737

Service Bulletin

Number: 737-24-1205
Original Issue: March 25, 2014
Revision 2: July 22, 2015
ATA System: 2400

SUBJECT: ELECTRICAL POWER - Standby Power System - Replacement of the M9 Static Inverter Terminal Lugs

FIGURE 1: MAIN EQUIPMENT CENTER - M9 STATIC INVERTER UNIT - TERMINAL LUG REPLACEMENT (SHEET 1 OF 2)

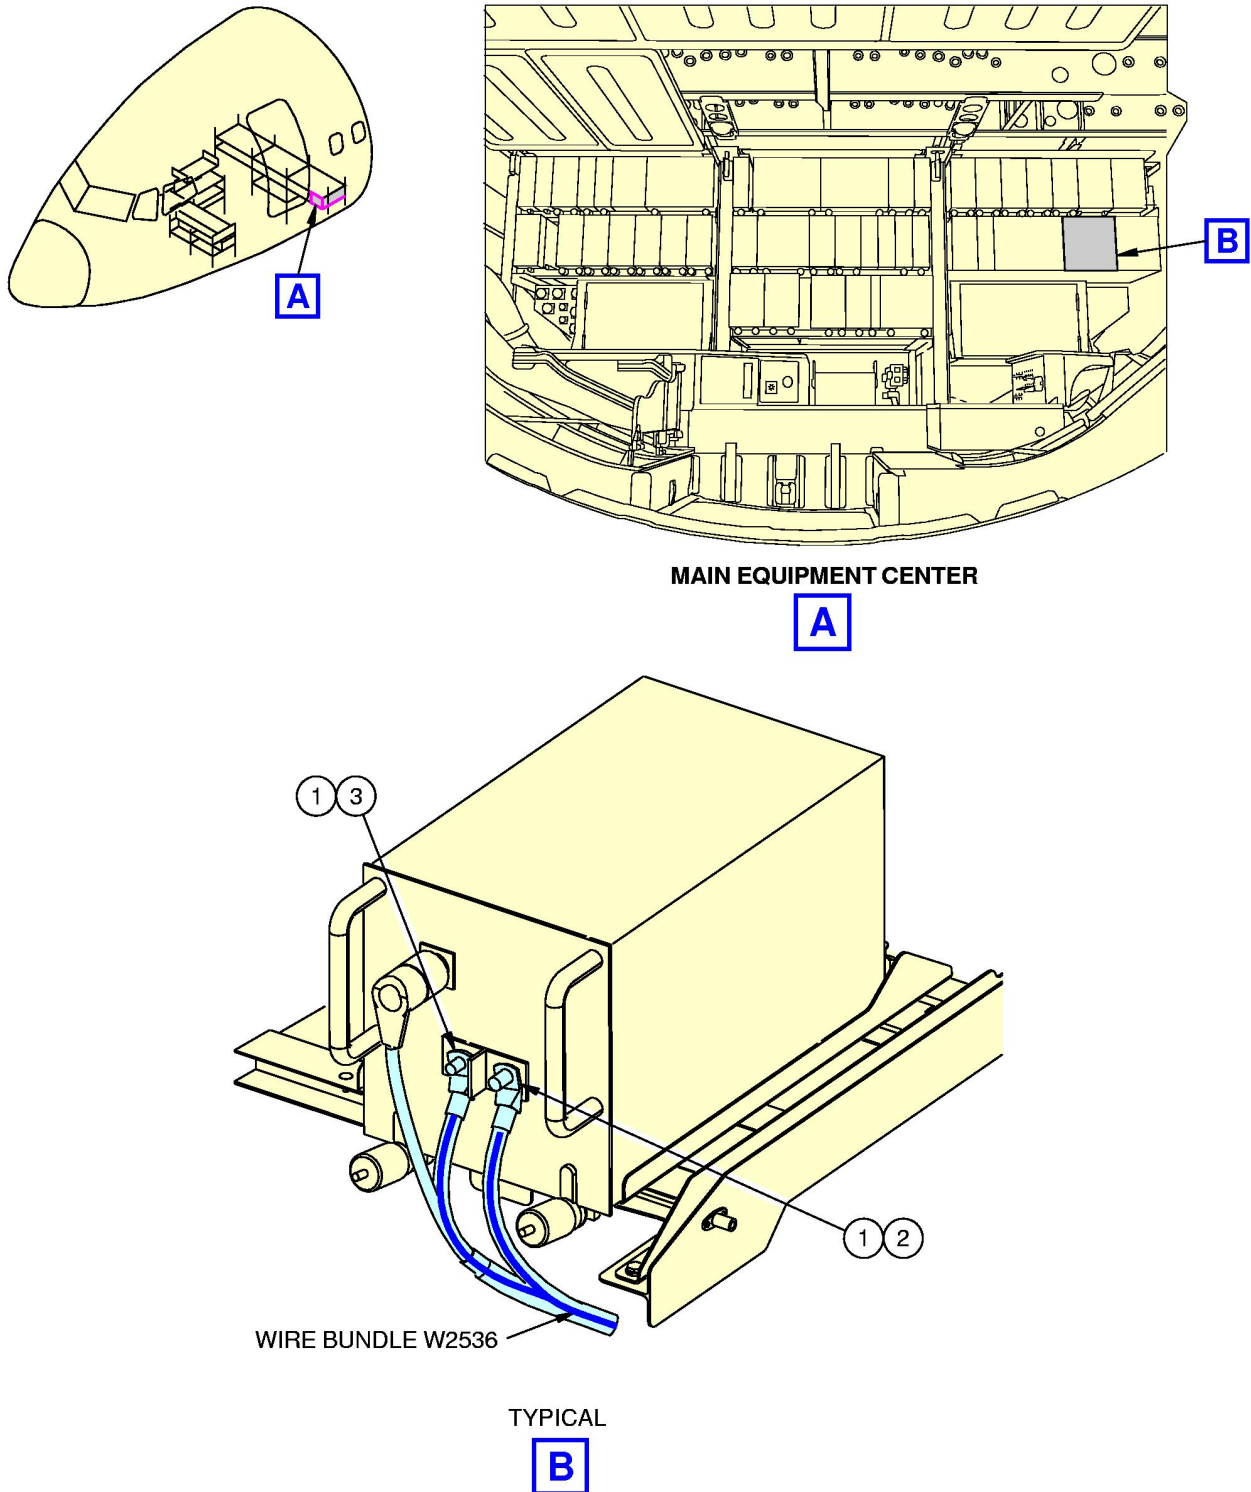
This revision is sent to correct the part number of the nut and washer that attach the positive terminal lug to the M9 static inverter. In addition, a footnote for an option to use existing nut and washer is removed from FIGURE 1 step table. This revision also corrects group effectivity by moving Group 2 airplanes to Group 1 since both group airplanes have the same configuration.

Revision 2 is sent to correct the part number of the nut and washer that attach the positive terminal lug to the M9 static inverter. In addition, a footnote for an option to use existing nut and washer is removed from FIGURE 1 step table. This revision also corrects group effectivity by moving Group 2 airplanes to Group 1 since both group airplanes have the same configuration.

Step	Task	Name	Identification	Qty	More Data
1	Remove	NUT	-	2	Remove the terminal block cover, if installed.
	Remove	WASHER	-	4	
	Remove	TERMINAL LUG	-	2	(a)
2	Install (New)	TERMINAL LUG	BACT12M8-3	1	(b) (c) (e)
	Install (New)	WASHER	NAS1149F0416P	1	(b)
	Install (New)	NUT	BACN10JC4CD	1	(b) (d)
3	Install (New)	TERMINAL LUG	BACT12M8-4	1	(b) (c) (f)
	Install (New)	WASHER	NAS1149F0516P	1	(b)
	Install (New)	NUT	BACN10JC5CD	1	Install the terminal block cover, if removed. (b) (d)

(d) Refer to SWPM 20-30-00 as an accepted procedure.					
(e) The terminal lug BACT12M8-3 for the wire W2536-0513-08. Refer to 737-600/700/800/900 WDM 24-34-11 as an accepted procedure.

(f) The terminal lug BACT12M8-4 for the wire W2536-0506-08. Refer to 737-600/700/800/900 WDM 24-34-11 as an accepted procedure.
